**Subject: Vermont Yankee Nuclear Power Station
License No. DPR-28 (Docket No. 50-271)
Technical Specification Proposed Change No. 264
Safety Limit Minimum Critical Power Ratio (SLMCPR) Change**

Proposed Technical Specification Change No. 264

Safety Limit Minimum Critical Power Ratio (SLMCPR) Change

Figure 2 - Cycle 24 Reference Core Loading Pattern

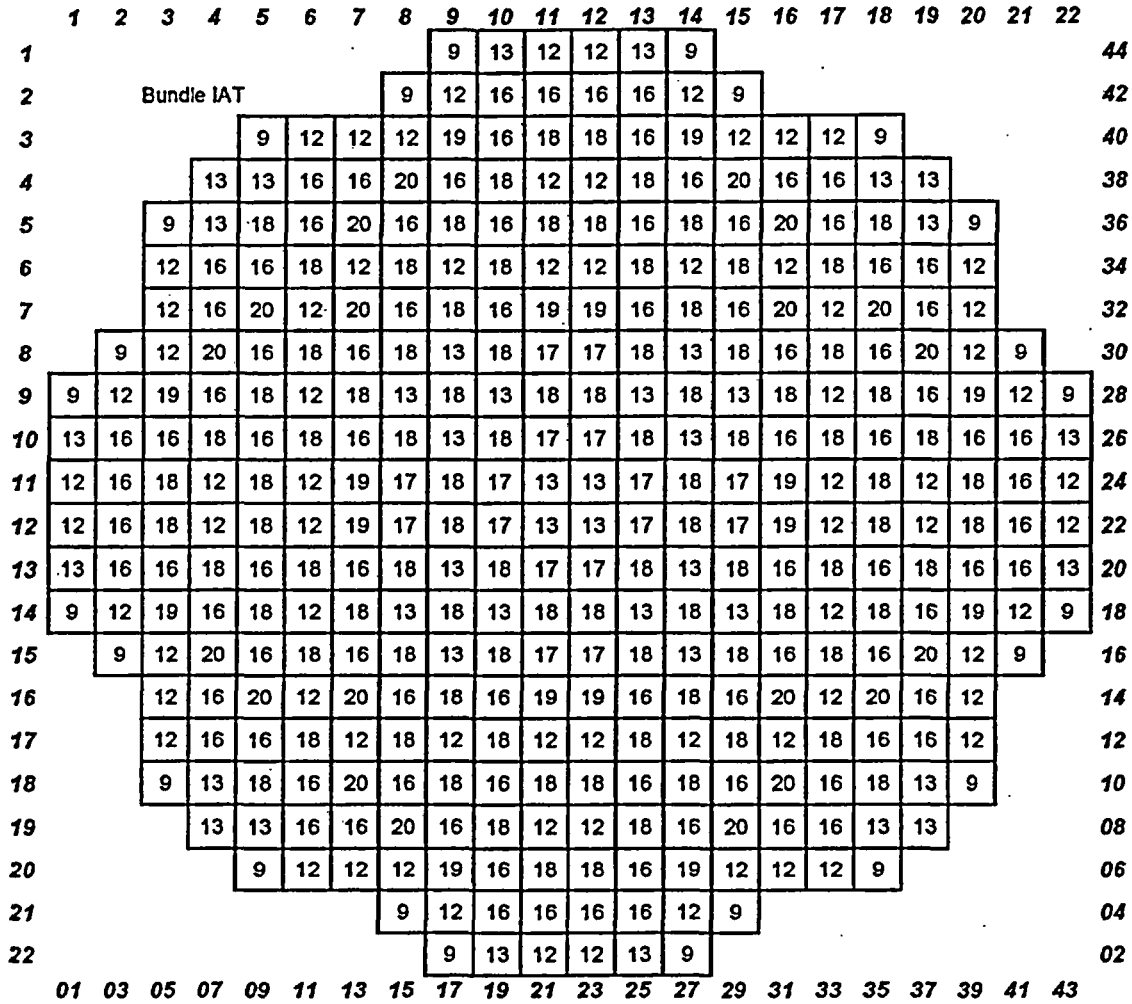
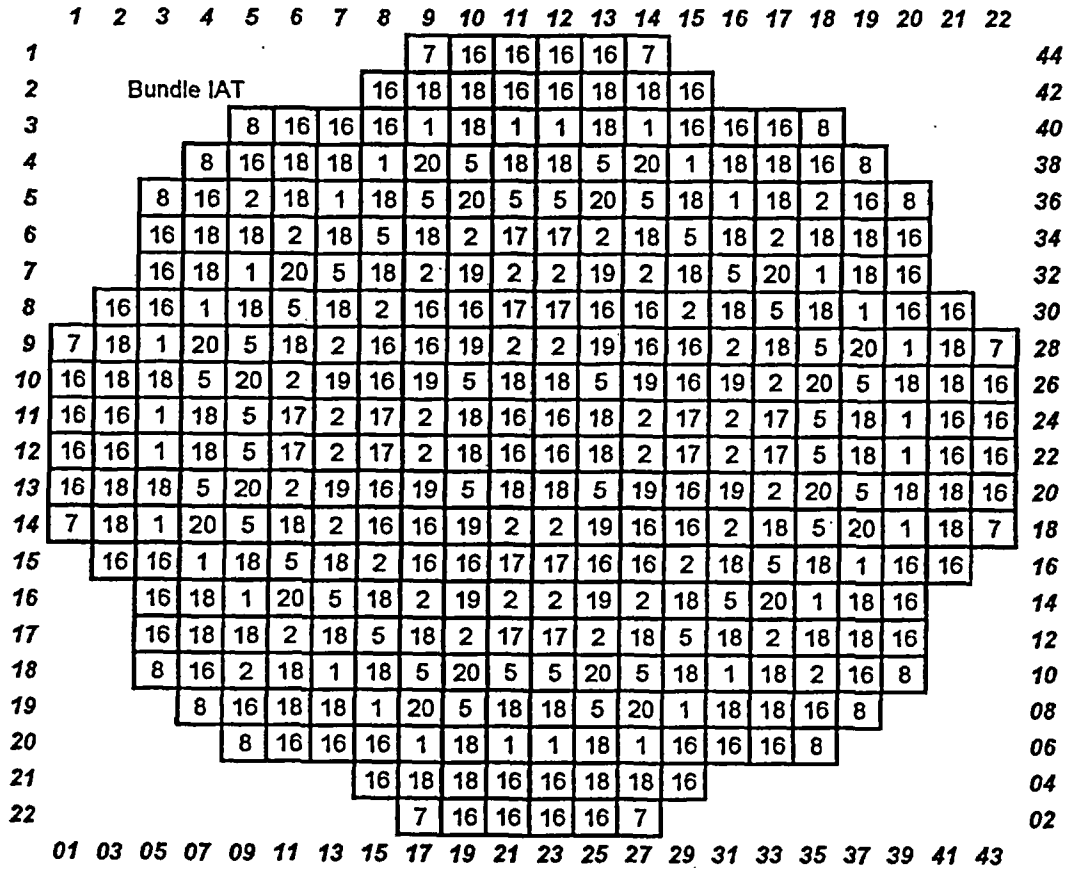
The core loading information for Vermont Yankee Cycle 23 is provided in Figure 1. For comparison the core loading information for Vermont Yankee Cycle 24 is provided in Figure 2. The impact of the fuel loading pattern differences on the calculated SLMCPR is correlated to the values of [[
